STATE OF NEW HAMPSHIRE
BEFORE THE SITE EVALUATION COMMITTEE
Docket No. SEC 2014-05

Petition for Jurisdiction Over a Renewable Facility by Antrim Wind Energy, LLC

Pre-Filed Testimony of Jean Vissering on behalf of

April 13, 2015

1B

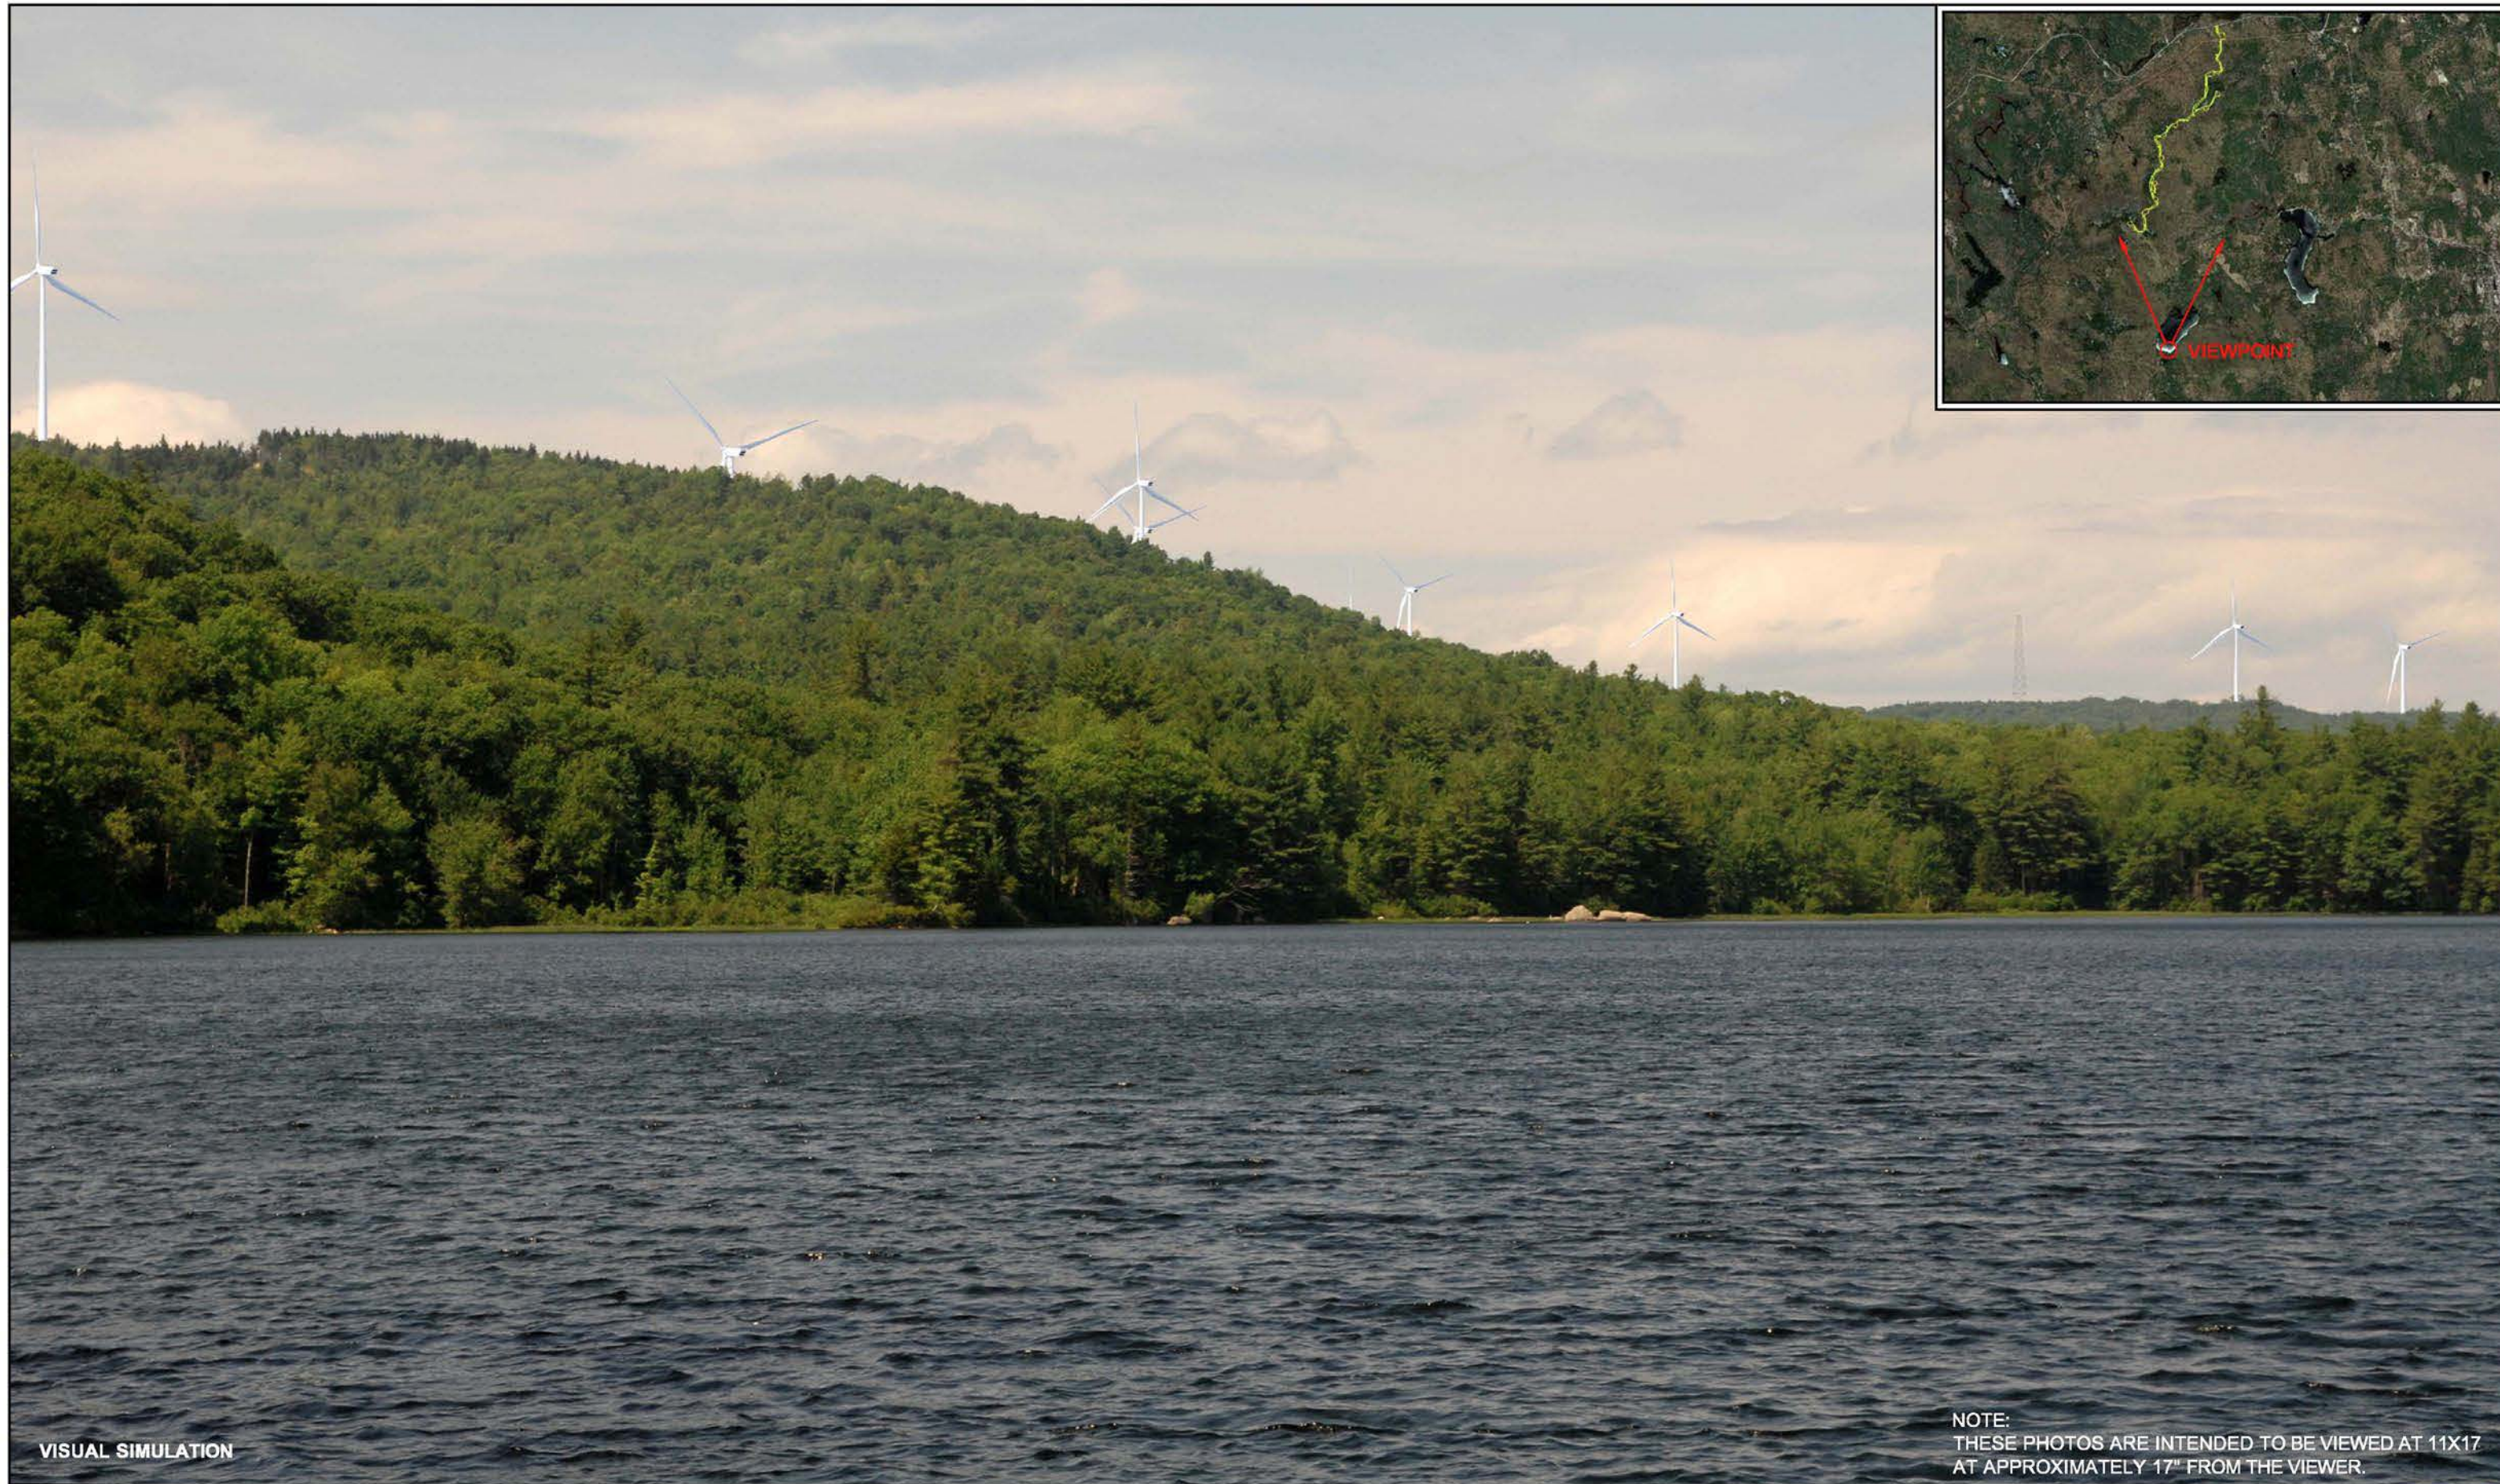
development currently visible from the pond. Because this is a wildlife sanctuary and Audubon Preserve, there is an expectation that one will experience a natural setting that will be different from settings such as Gregg Lake. The pond is very scenic and one of the area's more popular destinations. (See Appendix A Simulation 1B)

ANTRIM WIND PROJECT:
GREGG LAKE - NORTH NORTHWEST

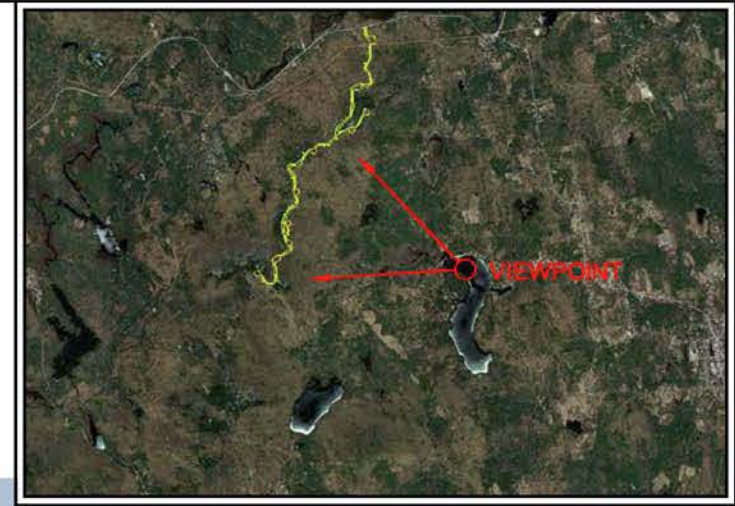
All 10 turbines as well as the met tower would be visible from various points on the lake and from the town beach/picnic area. They would also be seen in relatively close proximity with distances ranging from 1.8 miles to 2 miles away. The ridgeline is also fairly low in elevation ranging from 1,920 on Willard Mountain to 1,760 at the top of Tuttle Hill, and less on the lower portions of the ridge. Gregg Lake itself is at approximately 1040 feet above sea level. So the turbines at 492 feet in height will appear quite large in relation to the ridge itself. The beach is oriented away from the proposed project ridge and some foreground trees within this area will appear taller than the turbines moderating the apparent height and visibility of the turbines to some extent. Because the lake is developed and used by motorboats, there is not an expectation by users for an entirely natural setting as there is at Willard Pond. Nevertheless, the turbines will be a very dominant visual element from the vantage point of the picnic area, the lake itself and from portions of Gregg Lake Road.
